Model: R6400v2

Model: R6700v3

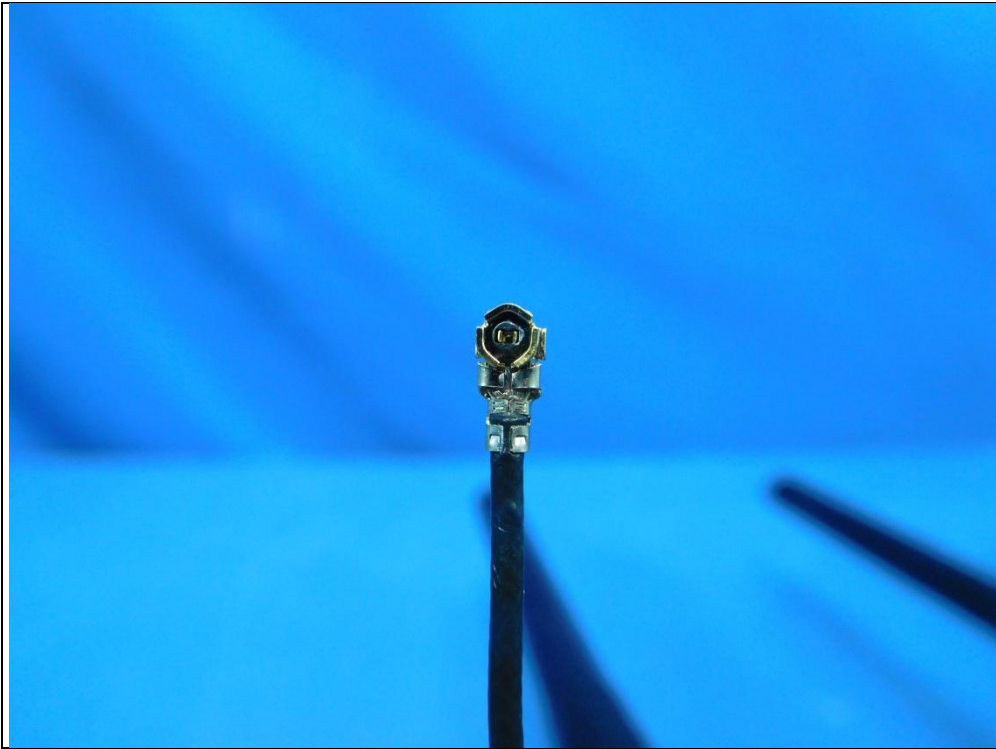
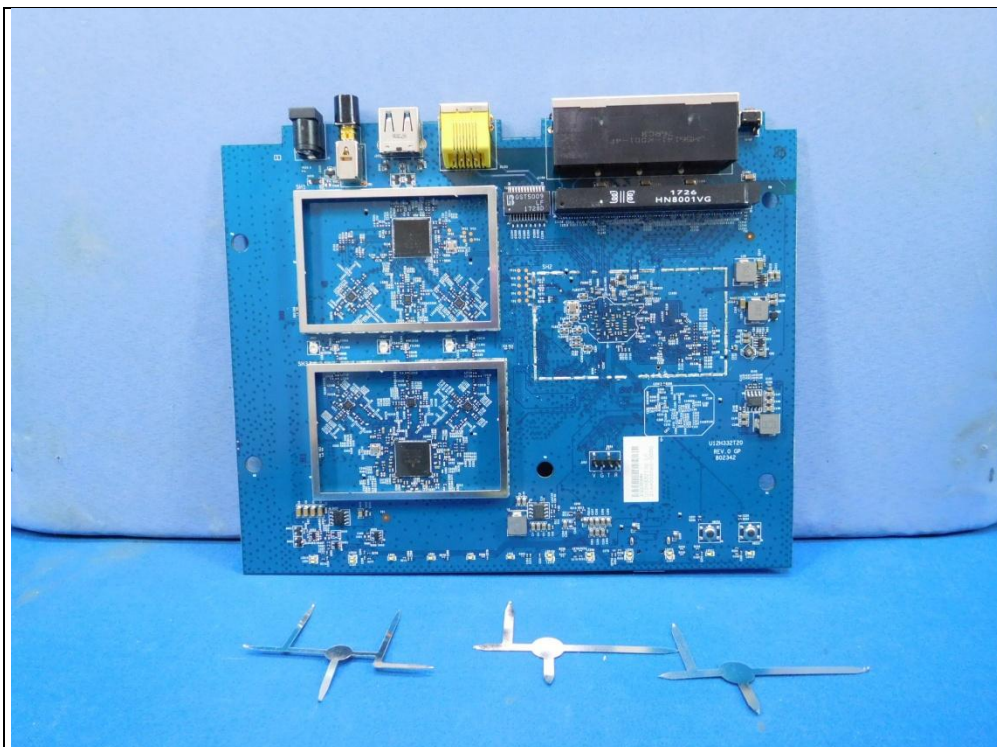
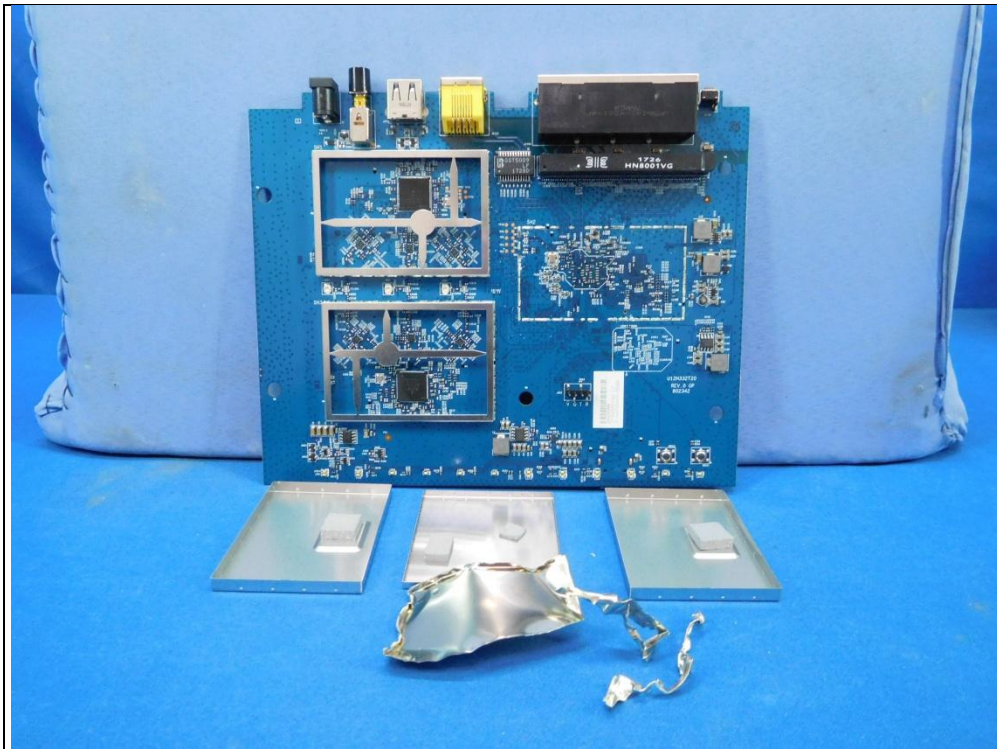
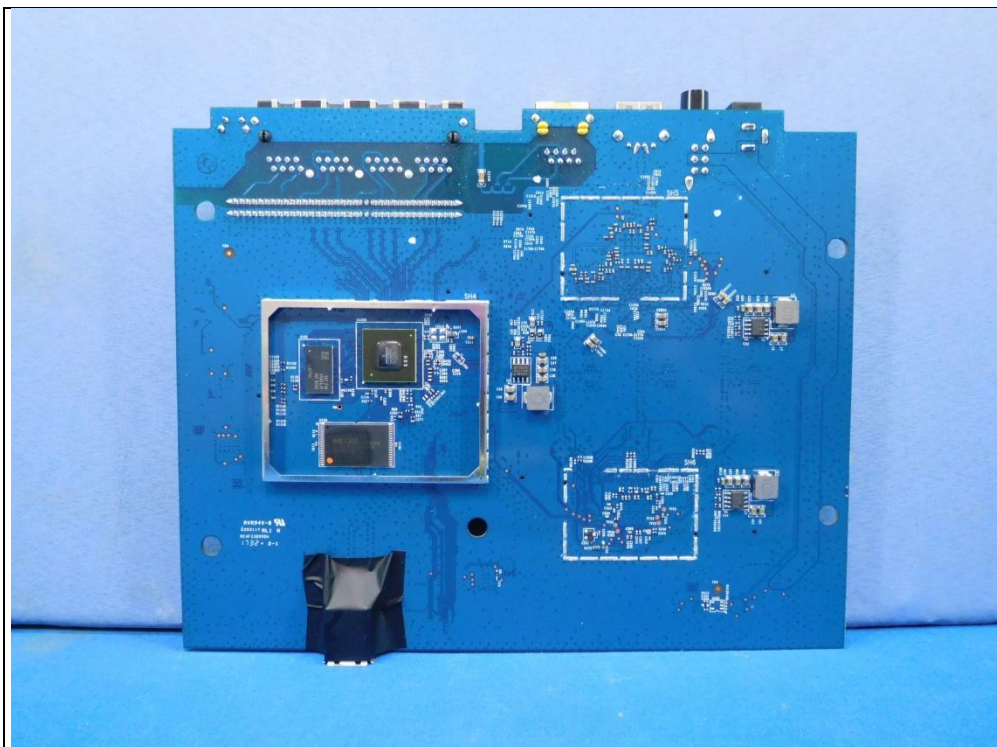
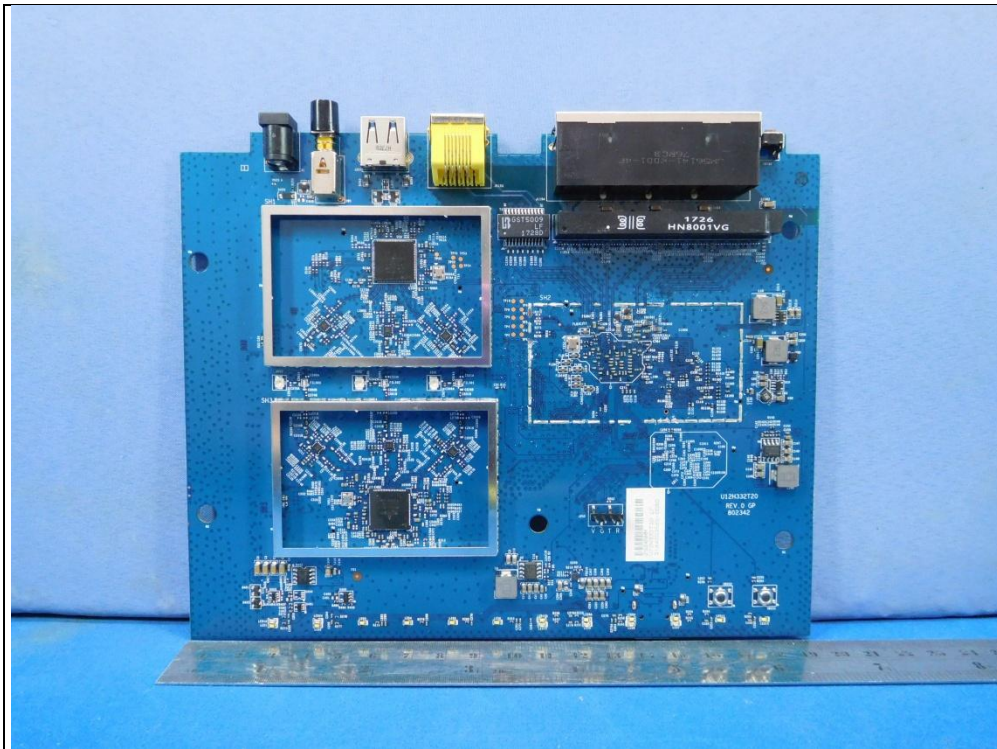
Reduce the heatspreader's size
Original: 226x127mm

Newly: 196x90 mm
